Rick Knowland - Construction Changes to the PNE project 0676901

2009-2010 SITEWORK CONTRACT
 PNE SCRAP METAL FACILITY
 RIVERSIDE STREET
 PORTLAND, MAINE
 PREPARED FOR:
 PROLERIZED NEW ENGLAND CO. LLC
 MAILING ADDRESS: 69 ROVER STREET, EVERETT, MA 02714, 02719

DRAWN: JAA CALC: CVB
 DATE: 29 OCTOBER 2009
 CHECKED:
 APPROVED:
 SCALE: 1" = 60'
 SHEET TITLE:
 • GRADING PLAN
 SHEET NUMBER:
 C4
 SHEET 4 of 8
 PROJECT # 06-769.02

DRAWN JAA CALC CVB
 DATE 29 OCTOBER 2009
 CHECKED CVB
 APPROVED
 SCALE 1" = 40'
 SHEET TITLE:
 • UTILITY PLAN

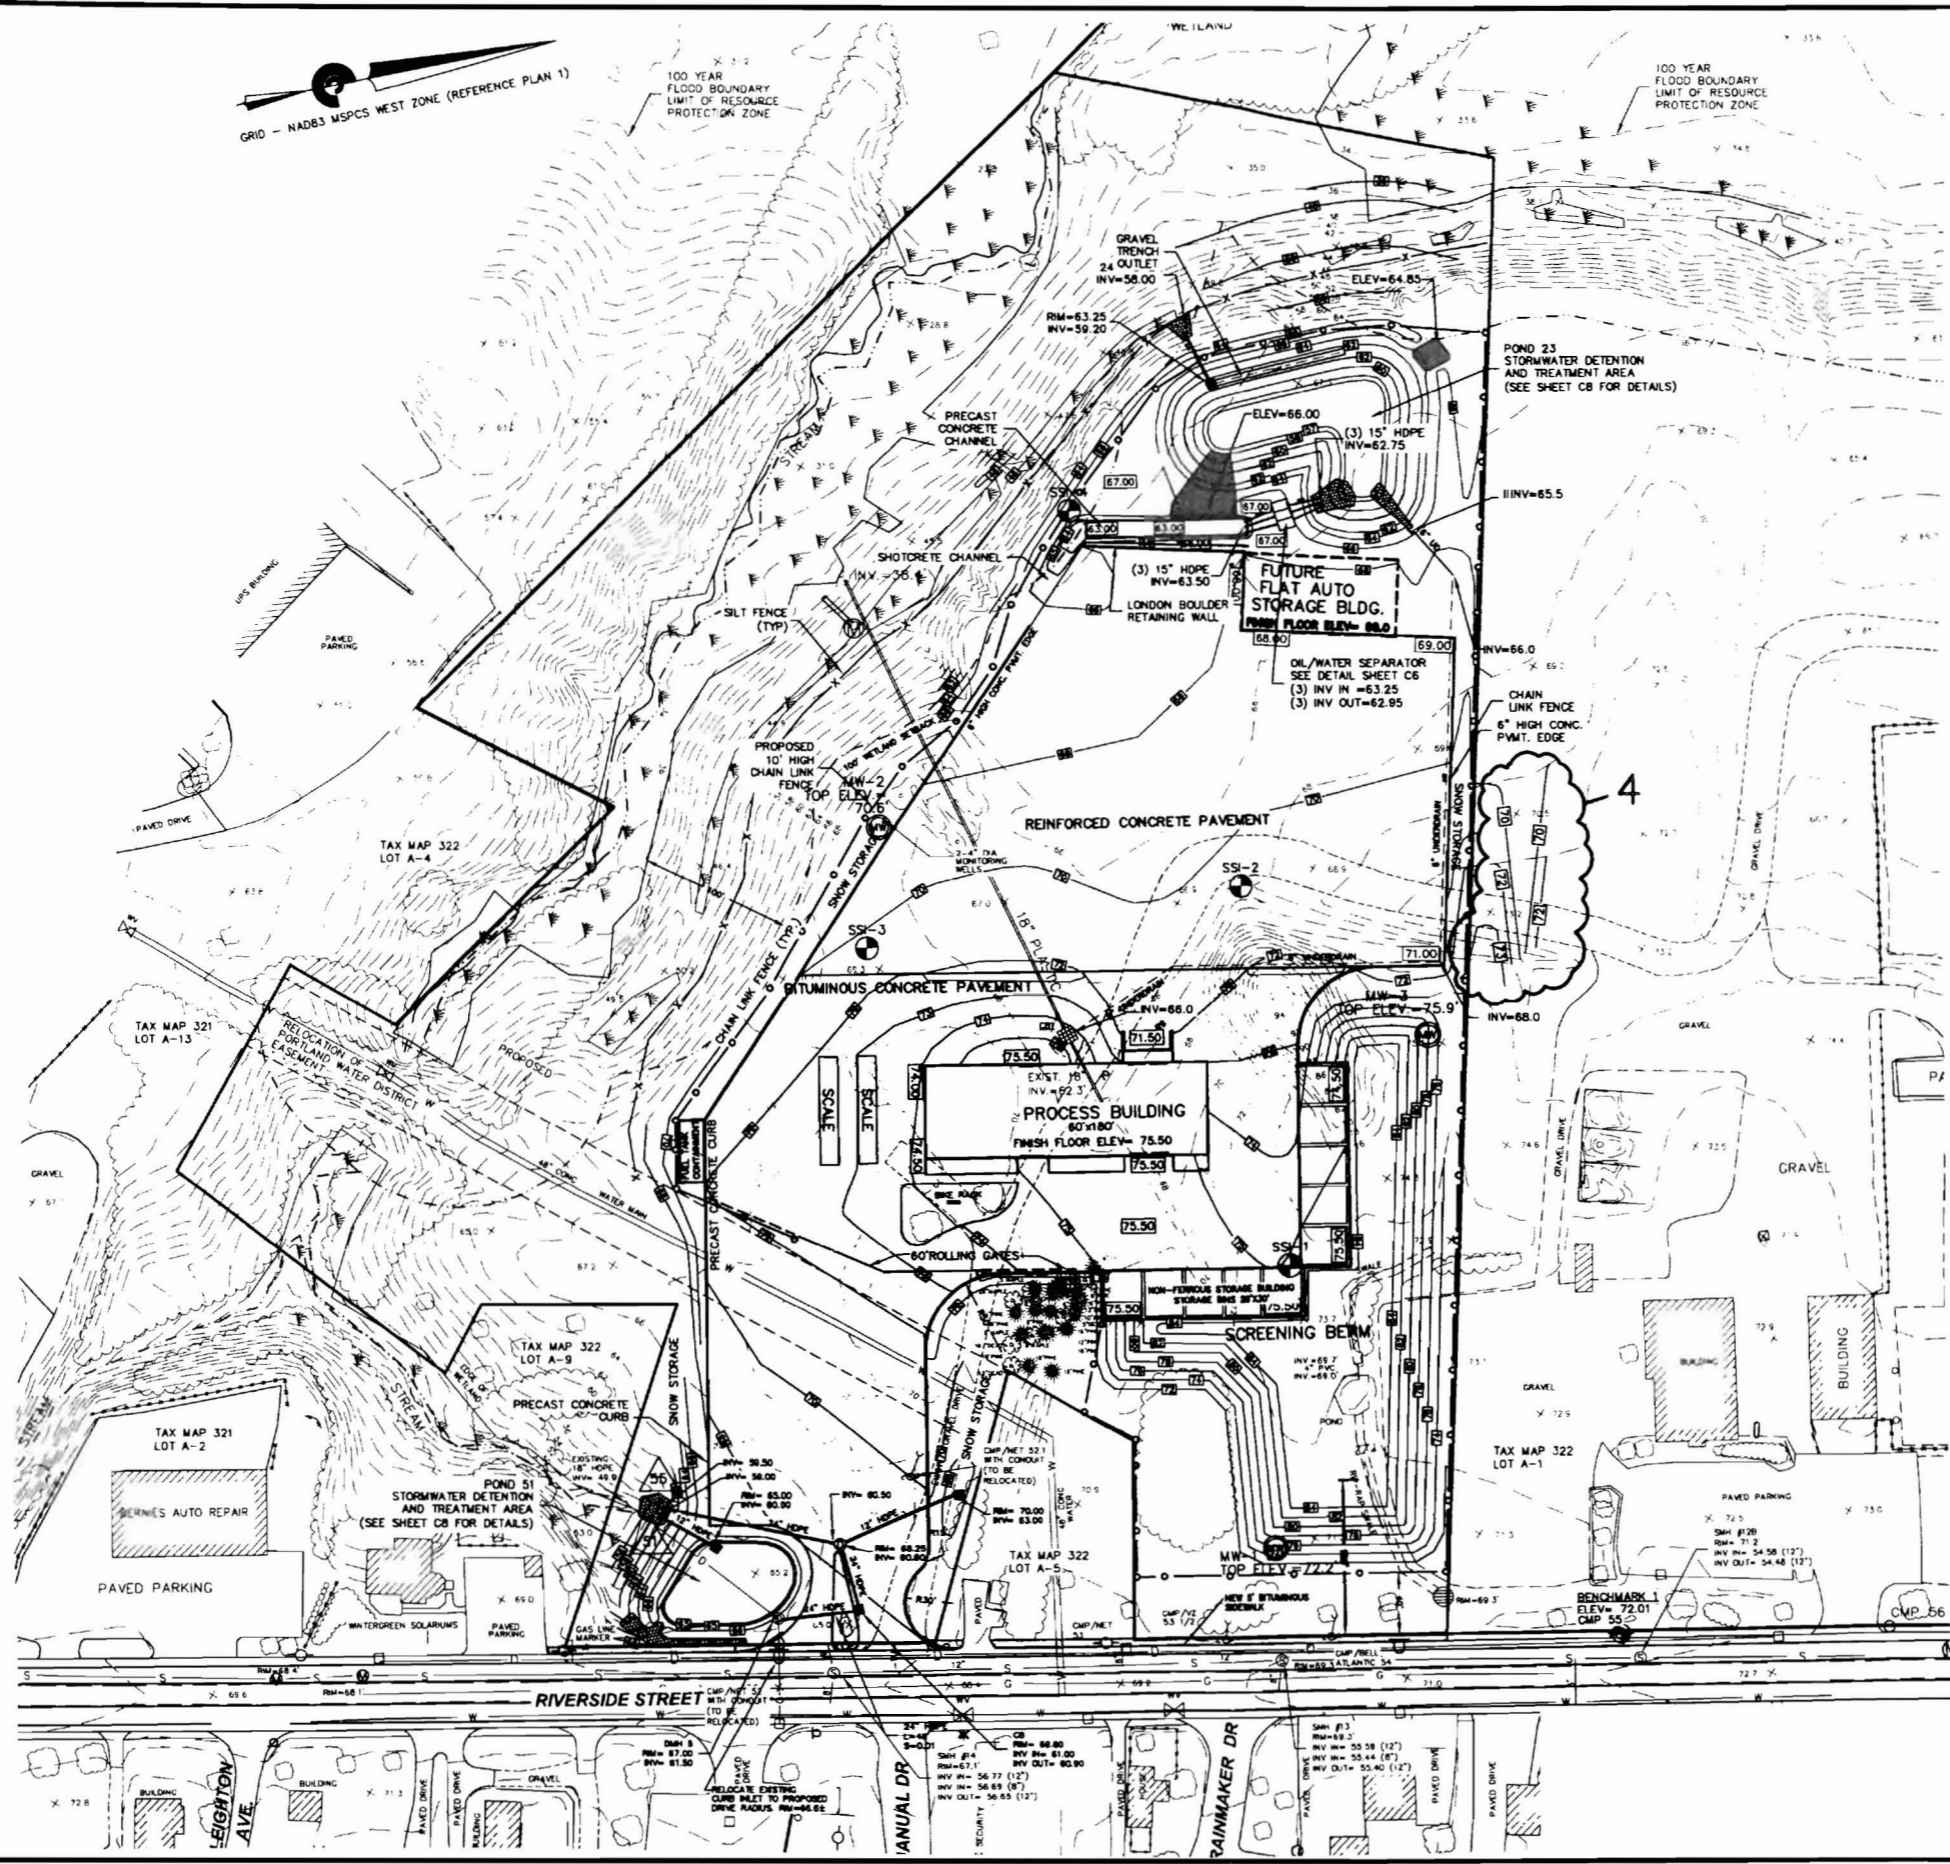
- Drawing C4 depicts that we are regrading a small area on the City parcel to contain stormwater runoff on that parcel and direct it away from the PNE site, toward the river. The new swale will seeded and mulched following construction.
- Drawing C5 depicts changes made to the on-site water main and hydrant location at the rear of the site. I believe that you were aware of this change and that the Fire Department also approved of the change.
